Number: SB 2X-71-17 R1
Issued: July 21, 2011
Revised: Sept 30, 2011

SNS SUBJECT: 71-60 AIR INTAKES - Disbonding Of Induction System Air Box Seal(s)

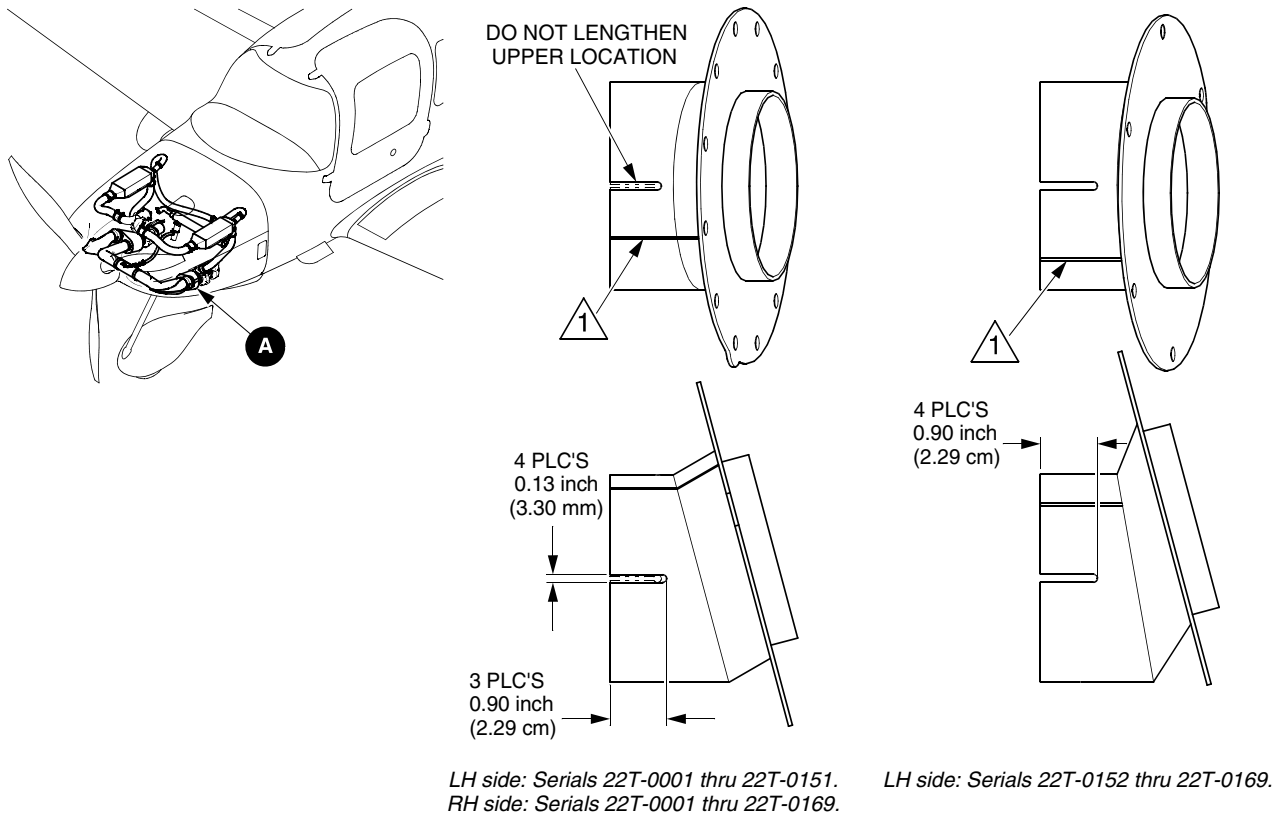
L. *All Affected Serials, RH Air Box Only:*

Using Cut-Off Tool, extend three of the four air box flange slots to 0.90 inch (2.29 cm) with full radius on the end. Do not extend the top slot nearest to the weld.

Figure 1
Air Box Seal Installation

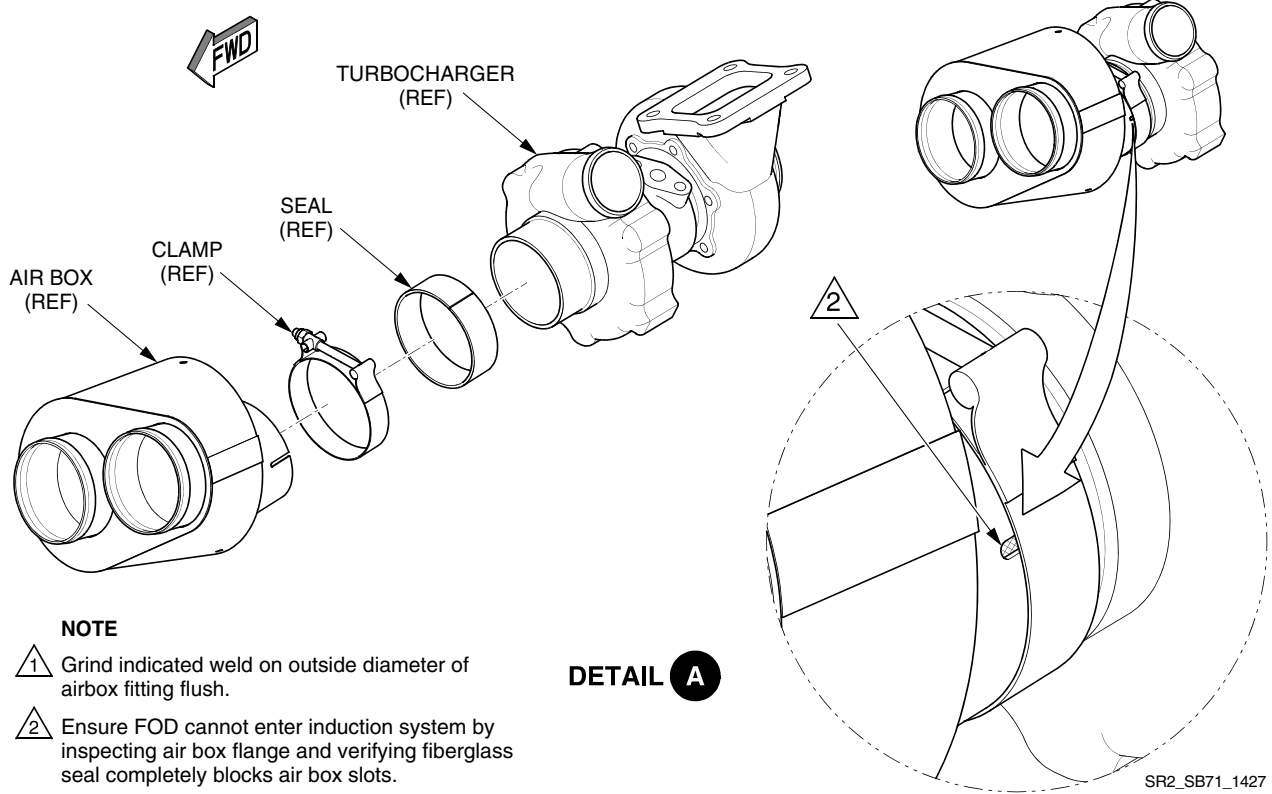
- B. Remove engine cowling. (Refer to AMM 71-10)
- C. Remove clamp securing air box to turbocharger.
- D. Disconnect air box from turbocharger.
- E. Remove and discard black rubber seal from air box.
- F. Remove residual adhesive from air box.
- G. Using Grinding Wheel, grind weld on outside diameter of airbox fitting flush to surrounding surface. (See Figure 1)

- H. *Affected Serials in Range 0001 thru 0151, LH Air Box Only;*
Using Cut-Off Tool, extend three of the four air box flange slots to 0.90 inch (2.29 cm) with full radius on the end. Do not extend the top slot nearest to the weld.
- I. *Affected Serials in Range 0001 thru 0151, LH Air Box Only;*
Using Cut-Off Tool, increase width of all four air box flange slots to 0.13 inch (3.30 mm).
- J. *Affected Serials in Range 0152 thru 0169, LH Air Box Only;*
Using Cut-Off Tool, extend all four air box flange slots to 0.90 inch (2.29 cm) with full radius on the end.
- K. *All Affected Serials, RH Air Box Only;*
Using Cut-Off Tool, increase width of all four air box flange slots to 0.13 inch (3.30 mm).

- T. Install air box over turbocharger induction mounting flange. Torque clamp to 90-100 in-lb (10-11 Nm).
- U. Ensure FOD cannot enter induction system by inspecting air box flange and verifying fiberglass seal completely blocks air box slots. (See Figure 1)
- V. Install clamp securing air box to turbocharger.
- W. Repeat procedure on opposite turbocharger.
- X. Install engine cowling. (Refer to AMM 71-10)
- Y. Complete airplane records by noting compliance with SB 2X-71-17R1 in Aircraft Logbook.
